工程指示 / 要求簡箋(E.I.)

工程指示編號：EI / 2921 / 21 修改版次：-
 工程編號 : J - 852 工程名稱 : 亞皆老街中電
 工程項目 : 佛沙窗 師父板 (3rd)
 收件人 : 生統 / 王良 發件人 : Ant Yeung 日期 : 07/01/2021

請按加工圖生產佛沙窗師父板 (收貨用)

Site Inspection Report # 06

Photo #9

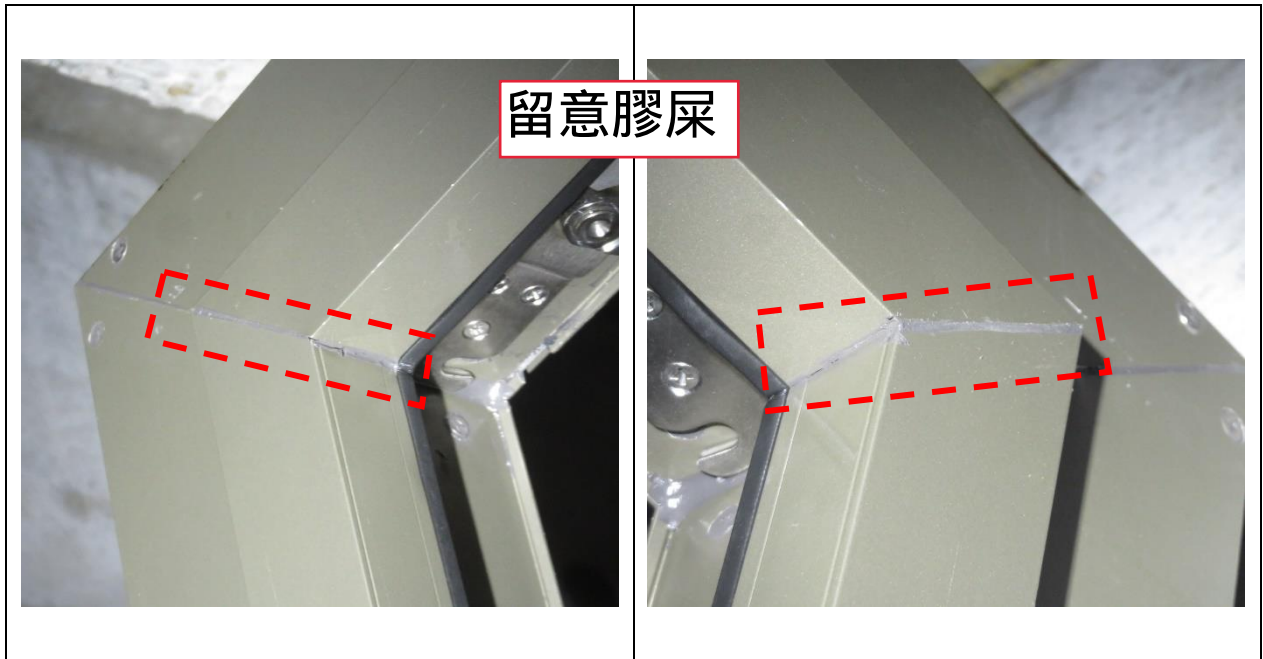
Observation (Window Frame)	Sealant was applied to the tight joints at window frame and sash. However, untidy sealant joints were observed.
Recommendation	Rectification work was carried out with reference to MFT's report 1980045.1MFHK-FI-RPT-002-00 Photo #13. Workmanship for sealant application should be improved.

Photo #12

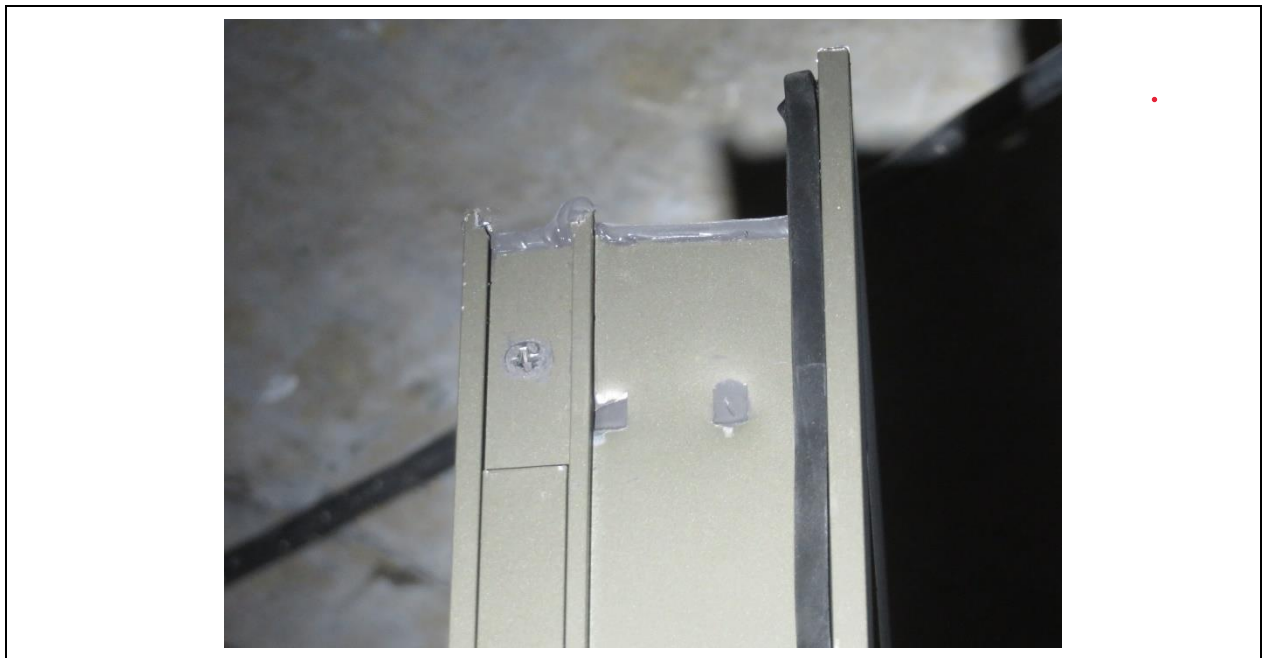
Observation (Window Sash)	Excessive sealant on the corner of a sash was removed.
Recommendation	Rectification work was carried out with reference to MFT's report 1980045.1MFHK-FI-RPT-002-00 Photo #16.

Photo #13

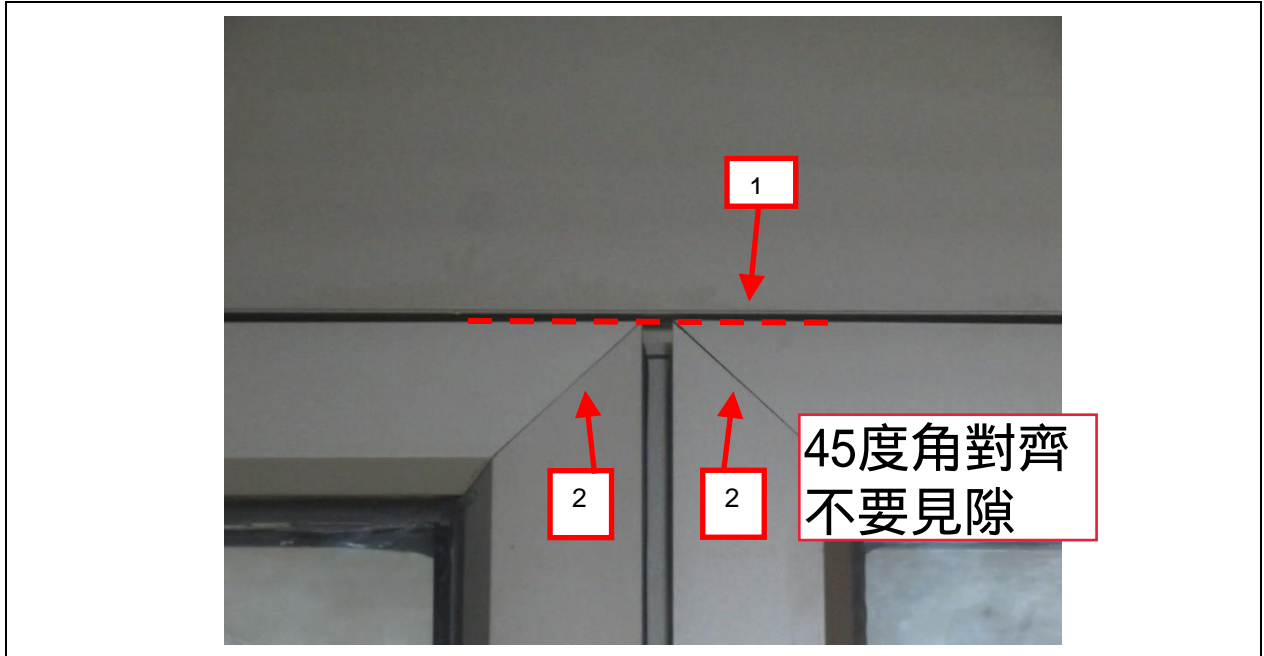
Observation (Window Sash)	1) Alignment between sashes was adjusted. 2) Uneven mitre joints could still be observed.
Recommendation	Rectification work was carried out with reference to MFT's report 1980045.1MFHK-FI-RPT-002-00 Photo #17. It is further reminded to improve the quality of fabrication as well as assembly in factory.

Photo #14

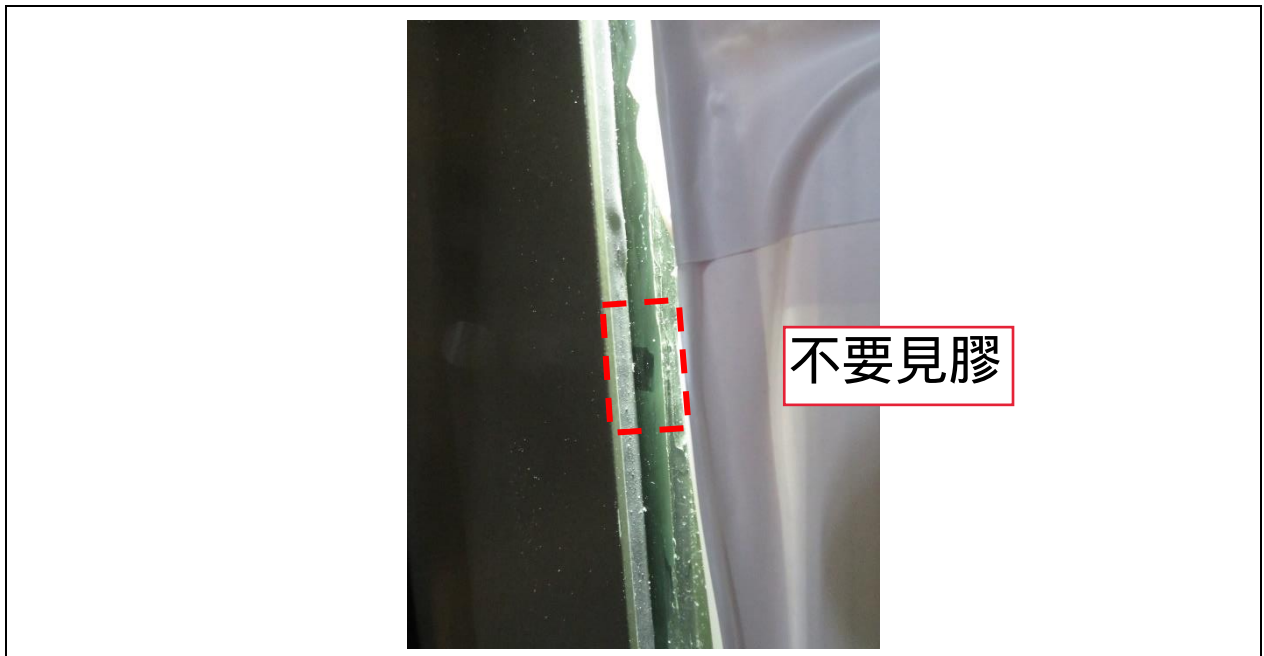
Observation (Glass Barrier)	Some spacers in the sealant joint around barrier glass were noticeable.
Recommendation	No rectification work was carried out with reference to MFT's report 1980045.1MFHK-FI-RPT-002-00 Photo #20.

Photo #16

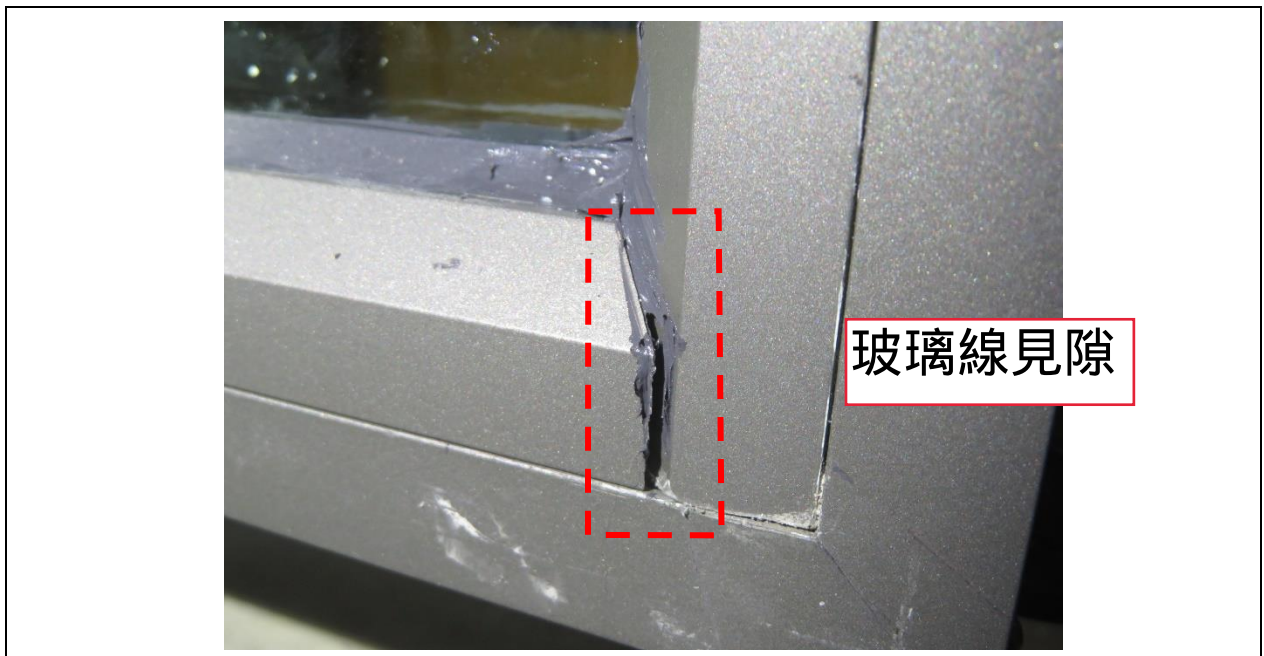
Observation (Window Sash)	Noticeable gap between glazing bead covers of sashes were observed.
Recommendation	Improvement in quality of fabrication as well as assembly is recommended.

Photo #17

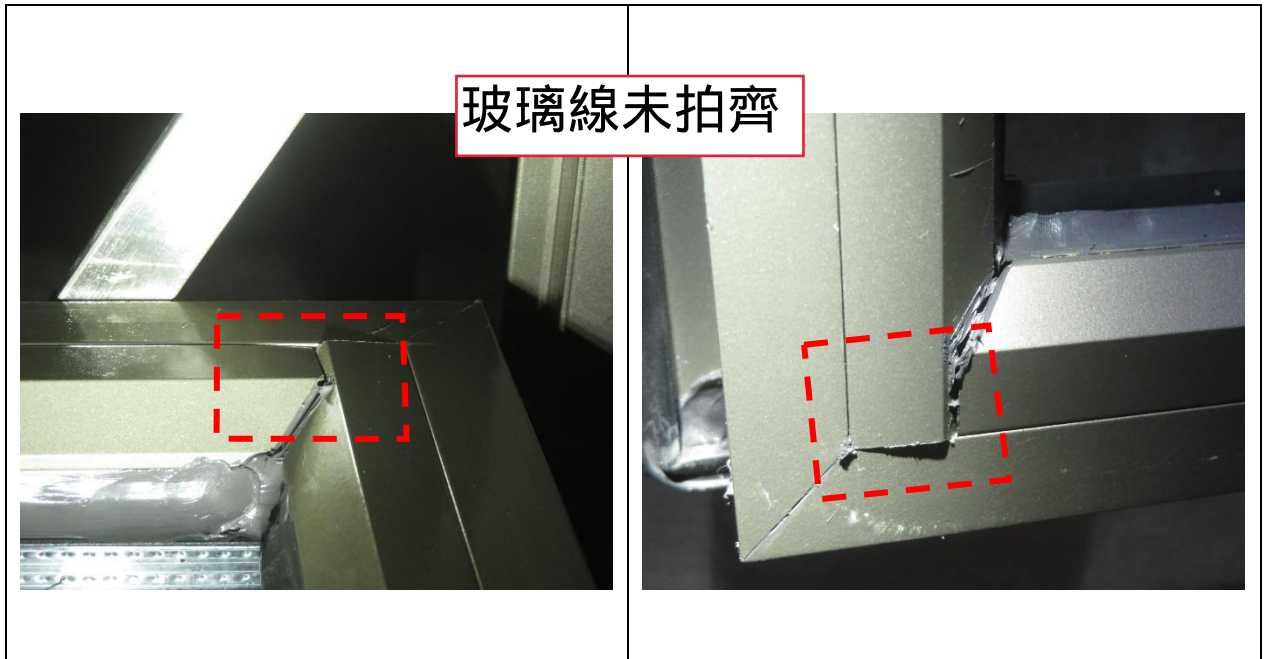
Observation (Window Sash)	Surfaces between glazing bead covers were not flush.
Recommendation	Rectification is required.

Photo #18

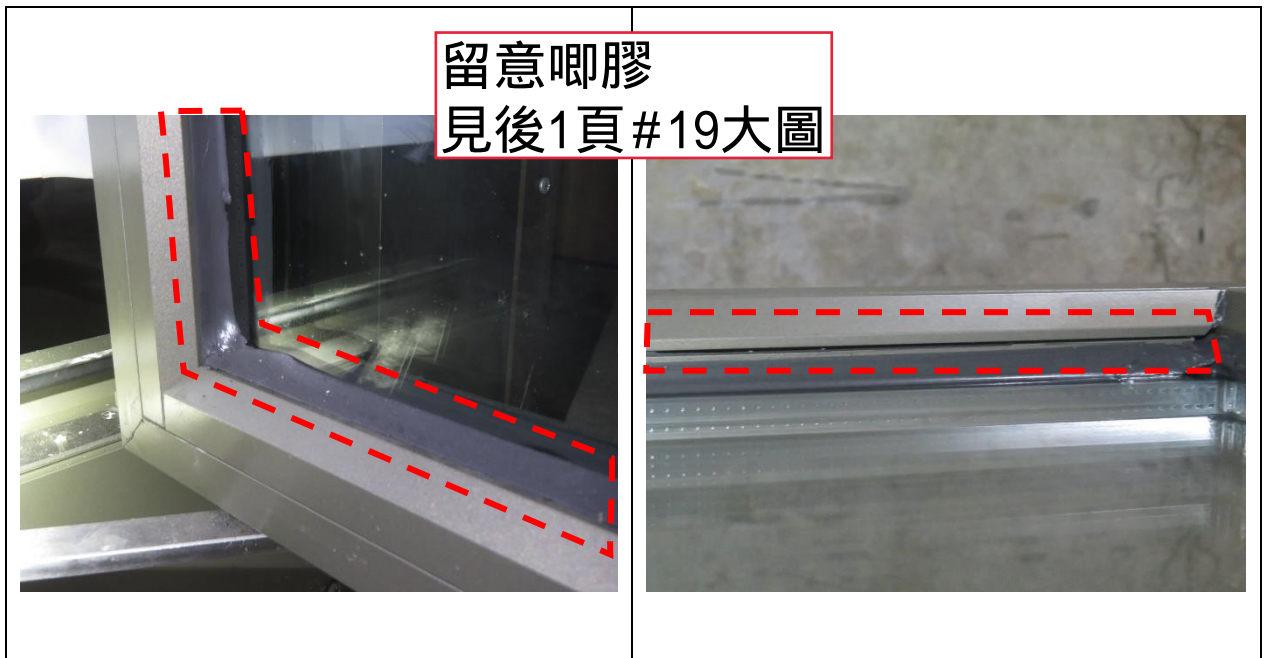
Observation (Window Sash)	Inconsistent glazing sealant of sashes (i.e. gaps between glazing beads and glazing bead covers were filled with sealant (LHS) or without sealant (RHS)). Please refer to Photo #19 for shop drawing detail.
Recommendation	Midi to clarify the inconsistency found. Rectification is required as per latest shop drawing.

Photo #19

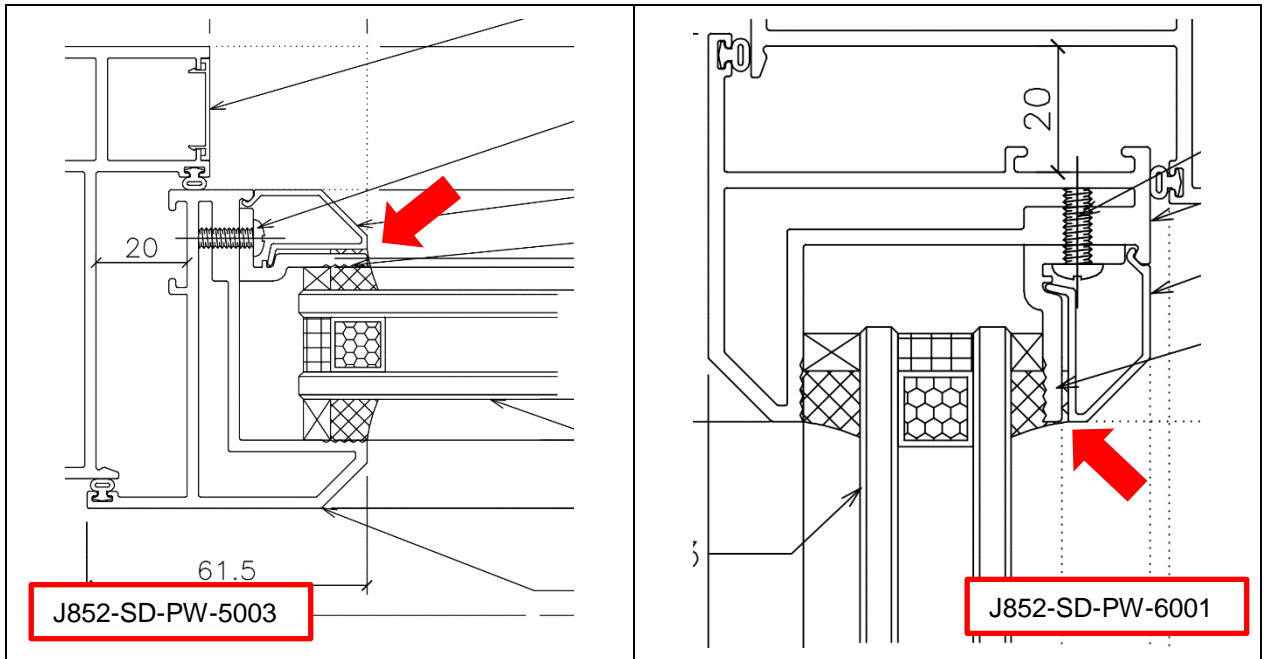
Observation	The above detail is extracted from latest shop drawings no. J852-SD-PW-5003 and J853-SD-PW-6001, sealant should be applied for the gap between glazing bead and its cover.
Recommendation	-

Photo #20

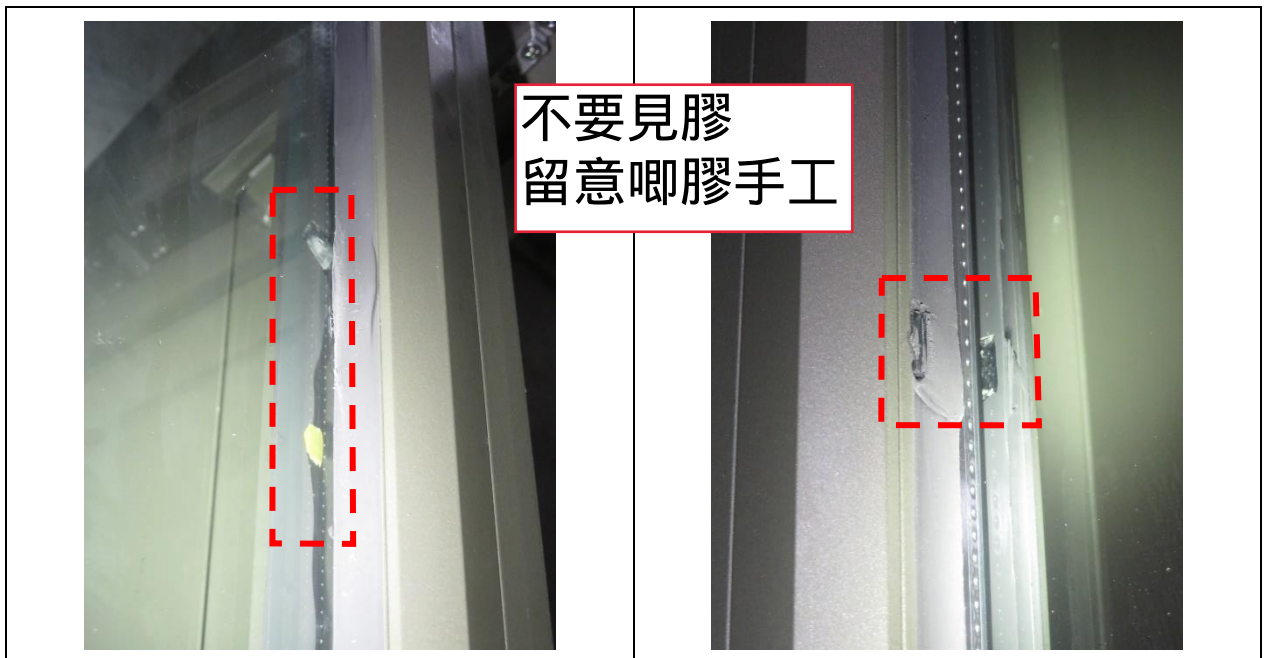
Observation (Window Sash)	Some spacers in the glazing sealant of sashes were noticeable.
Recommendation	Rectification is required.

Photo #21

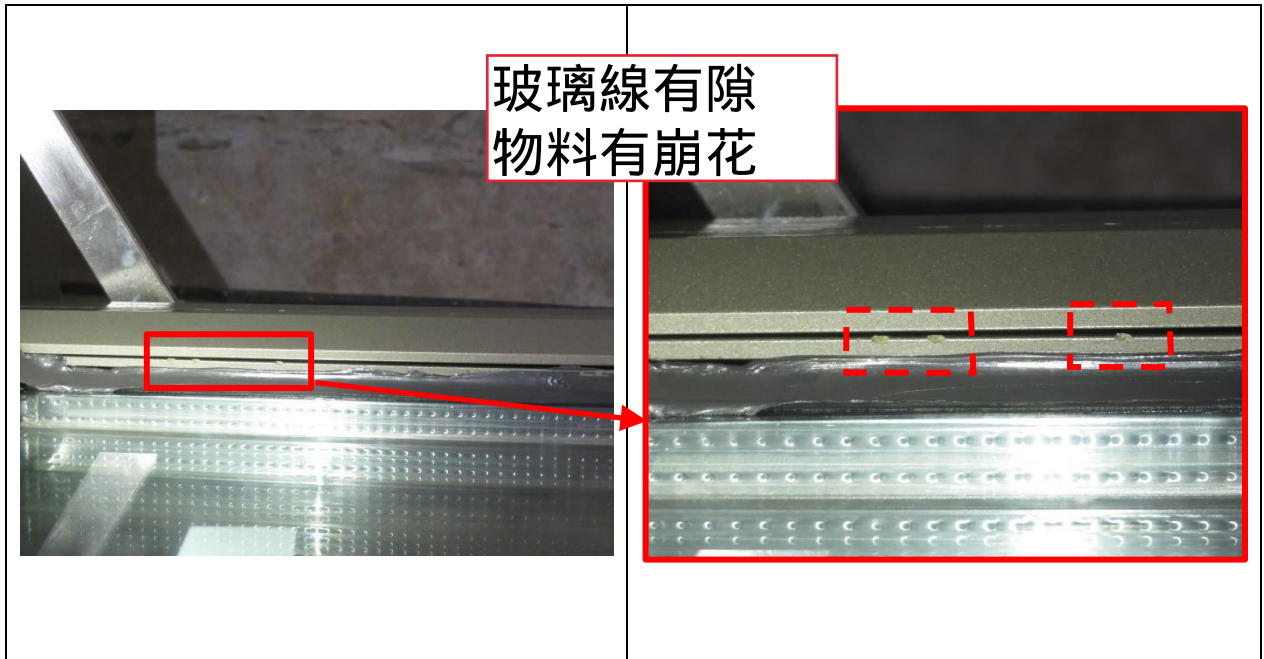
Observation (Window Sash)	LHS: Significant gap between glazing bead and glazing bead cover was noted. RHS: Damages were observed on the edge of glazing bead.
Recommendation	Please refer to Photo #16 for comment. Review of protection and handling of material are recommended.

Photo #22

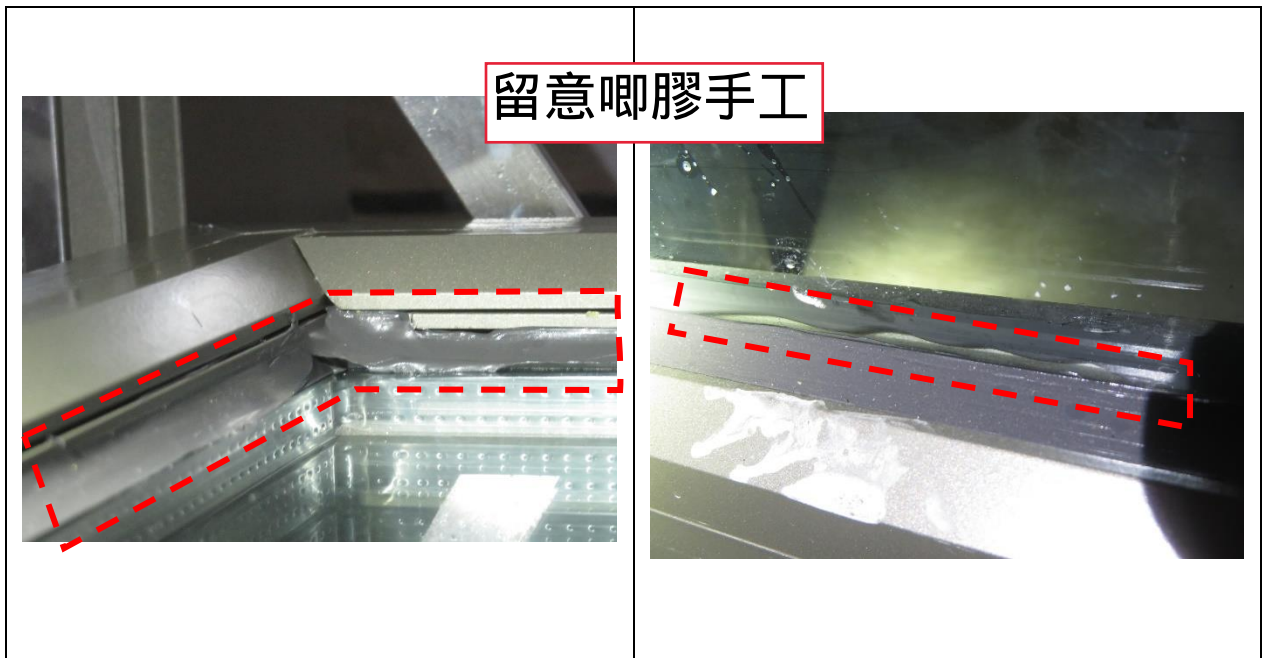
Observation (Window Sash)	Poor workmanship of glazing sealant was generally observed.
Recommendation	Rectification is required. Workmanship for sealant application should be improved.

Photo #23

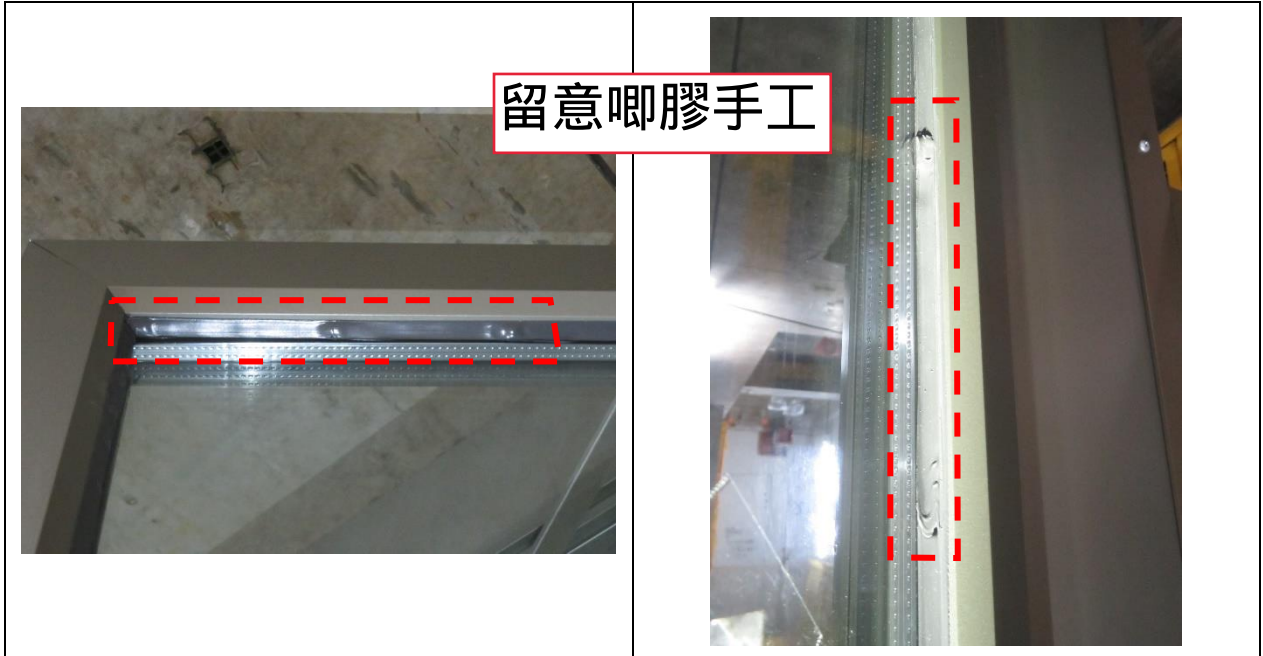
Observation (Window Sash)	Ditto.
Recommendation	Ditto.
